SERVICE BULLETIN MAINTENANCE OF WAY EQUIPMENT

MAINTENANCE OF WAT EQUI MENT				
DATE : 1 - 20	008			BULLETIN NO : 08-00 ⁻
TITLE: Hydraulic Pump Motor Rework				
RATING:		ALERT (Potential Problem)		INFORMATION (Action Is Optional)
	X	DIRECTIVE (Action Is Required)		PRODUCT IMPROVEMENT (Enhance Product)
PRODUCT SERIES / MODEL: HR1500 Series B2, HR1500 Series B3 and HR2000 Series HY-RAIL® guide wheel units equipped with a HTT #202 #3409145 Hydraulic Power Unit.				its equipped with a HTT #202514 or
SERIAL NO:	N/A			
SUMMARY:	A design change in the electric motor that powers the HTT # 202514 and #3409145 hydraulic power units is allowing water to enter the electric motor. The water that is entering the motor may be from a number of sources such as normal rain fall, road spray, power washing the vehicle, etc. The manufacturer of the electric motor and HTT have determined that to help eliminate this problem, a water drain hole will need to be drilled in the bottom of the electric motor housing.

FIGURE 2
DRILLING DRAIN HOLE IN MOTOR HOUSING - BOTTOM OF MOTOR SHOWN

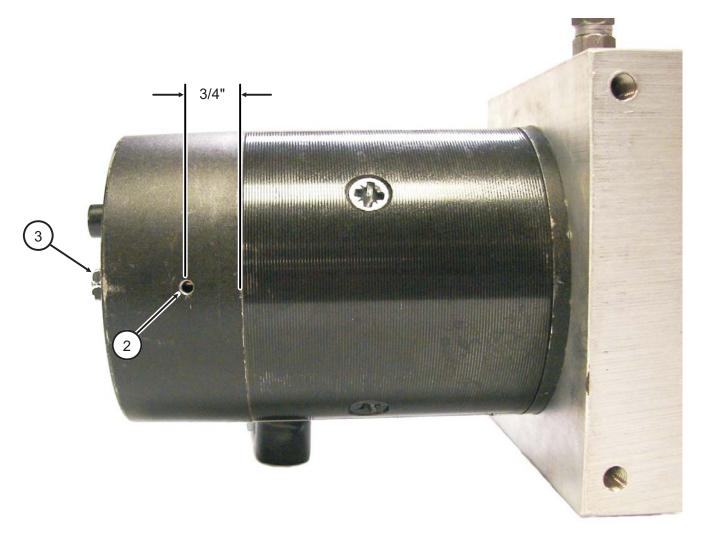
- 3. See Figure 2. In the very bottom of the motor housing, measure and mark 3/4 inch (19 mm) from the housing seam as shown. Center punch on the measured mark to help start the drill bit.

- 4. Using a 3/16 inch drill dit, drill hole (2) through the motor housing. This should be less than 3/8 inch (10 mm) deep to drill through the housing. Keep in mind that the drilled hole may be directly in line with the assembly bolt (3). The drill bit may touch the assembly bolt when it goes through the motor housing but do not drill into the assembly bolt.
